APPLICATION NO.	FILING DATE	FIRST NAMED INVENTOR	ATTORNEY DOCKET NO.	CONFIRMATION NO.
10/600,203	06/20/2003	Grant M. Kloster	42P17058	8820
8791	7590 02/03/2005		EXAM	INER
BLAKELY SOKOLOFF TAYLOR & ZAFMAN 12400 WILSHIRE BOULEVARD SEVENTH FLOOR			NGUYEN, KHIEM D	
			ART UNIT	PAPER NUMBER
LOS ANGEL	ES, CA 90025-1030		2823

Application No.	Applicant(s)				
Office Action Summany	10/600,203	KLOSTER ET AL.				
Office Action Summary	Examin r	Art Unit				
	Khiem D Nguyen	2823				
The MAILING DATE of this communication app Period for Reply	ears on the cover sh et with the c	orrespondence address				
A SHORTENED STATUTORY PERIOD FOR REPLY IS SET TO EXPIRE 3 MONTH(S) FROM THE MAILING DATE OF THIS COMMUNICATION. - Extensions of time may be available under the provisions of 37 CFR 1.136(a). In no event, however, may a reply be timely filed after SIX (6) MONTHS from the mailing date of this communication. - If the period for reply specified above is less than thirty (30) days, a reply within the statutory minimum of thirty (30) days will be considered timely. - If NO period for reply is specified above, the maximum statutory period will apply and will expire SIX (6) MONTHS from the mailing date o

Fig. 1

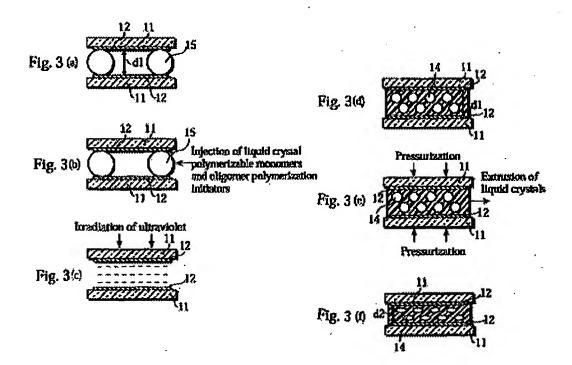
In re claim 1, <u>Nakao</u> discloses a method, comprising (col. 16, line 23 to col. 17, line 13 and FIGS. 1-42): forming a layer of first material (polymerizable

monomers) (col. 16, lines 65-66) between two substrates 11 of a stacked device; forming a layer of second material (oligomers or liquid crystals) (col. 16, lines 65-66) between the two substrates of the stacked device, wherein the second material causes a reaction in a portion of the first material (col. 16, line 65 to col. 17, line 13 and FIGS. 1-3).

In re claim 2, <u>Nakao</u> discloses wherein the reaction comprises polymerization (col. 16, line 65 to col. 17, line 22 and FIGS. 1-3).

In re claim 3, <u>Nakao</u> discloses wherein forming the layer of first material comprises diffusing the first material between a portion of the two substrates (FIG. 1: 11) of the stacked device (col. 16, lines 23-34).

In re claim 26, <u>Nakao</u> discloses a method, comprising (col. 16, line 23 to col. 17, line 13 and FIGS. 1-42): forming a layer of material (polymerizable monomers) (col. 16, lines 65-66) between two substrates 11 of a stacked device; and reacting a portion of the layer of material, wherein the reaction results in the portion of the layer of material increasing in volume (col. 16, line 65 to col. 17, line 13 and FIGS. 1-3).

In re claim 30, Nakao discloses a method comprising (col. 16, line 23 to col. 17, line 13 and FIGS. 1-42): depositing a first material (polymerizable monomers) (col. 16, lines 65-66) between two substrates 11 of a stacked device; depositing a second material (oligomers or liquid crystals) (col. 16, lines 65-66) between the two substrates of the stacked device; and filling a portion of the area between the two substrate with a polymer foam as a product of a reaction between the first material and the second material (col. 16, line 65 to col. 17, line 13 and FIGS. 1-3).
